# Rezoning Transportation Analysis

Petition Number: #2021-277

General Location Identifier: 15501125, 15501126

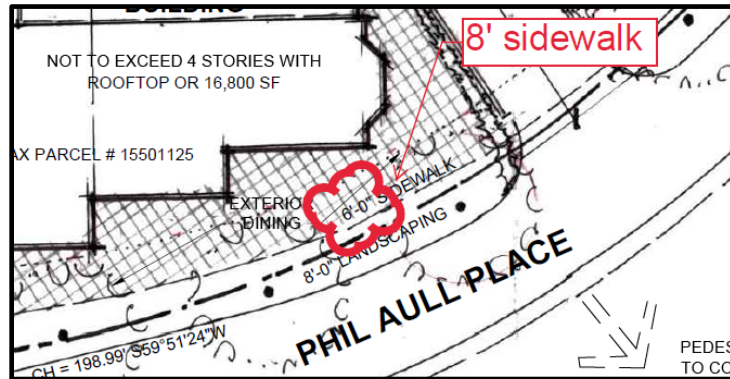
### 3. ~~Outstanding Comment from 5-18-22:~~ Revise site plan and conditional notes to commit to dedicate 40 ft (min) right-of-way from the Providence Road centerline. Provide a sidewalk utility easement (SUE) 2 ft behind the future back of sidewalk (50.5 ft from the centerline). The site plan shall label and dimension the right of way from the road centerline.

~~**Clarifying Comment from 10-26-2022:** Provide and show sidewalk utility easement (SUE) 2 ft behind the future back of sidewalk (50.5 ft from the centerline) on Providence Road.~~

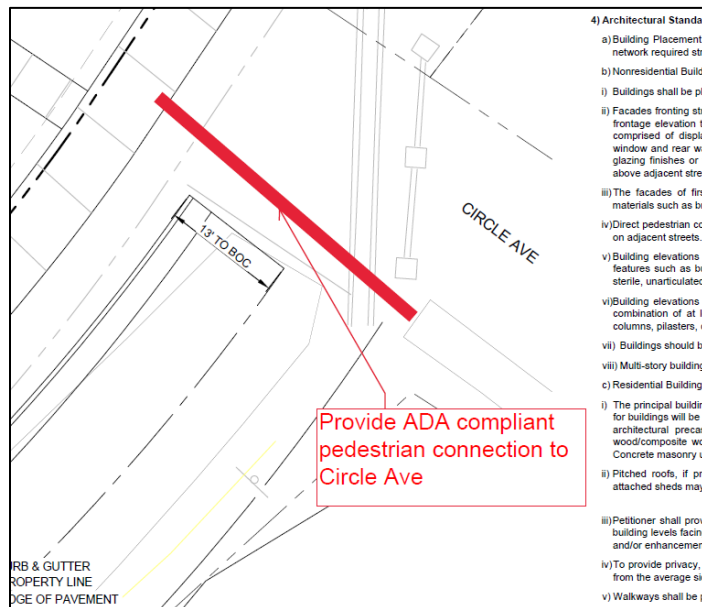
6. ~~Outstanding Comment from 5-18-22:~~ Site plan and conditional notes revisions are needed to provide an ADA compliant pedestrian connection from Phill Aull Place to Circle Avenue.

~~Clarifying Comment 10-27-22:~~ Label and add conditional note committing to ADA compliant connection.

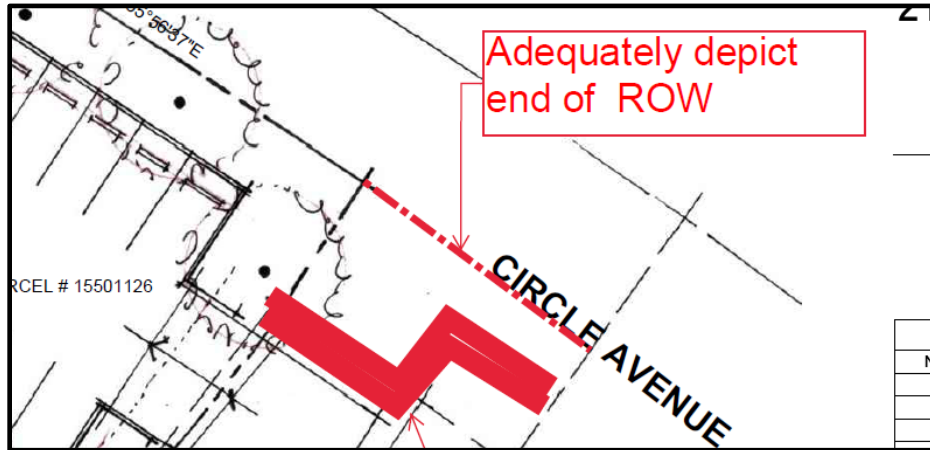
7. ~~Adequately depict the existing Circle Avenue right of way at Phill Aull Place.~~
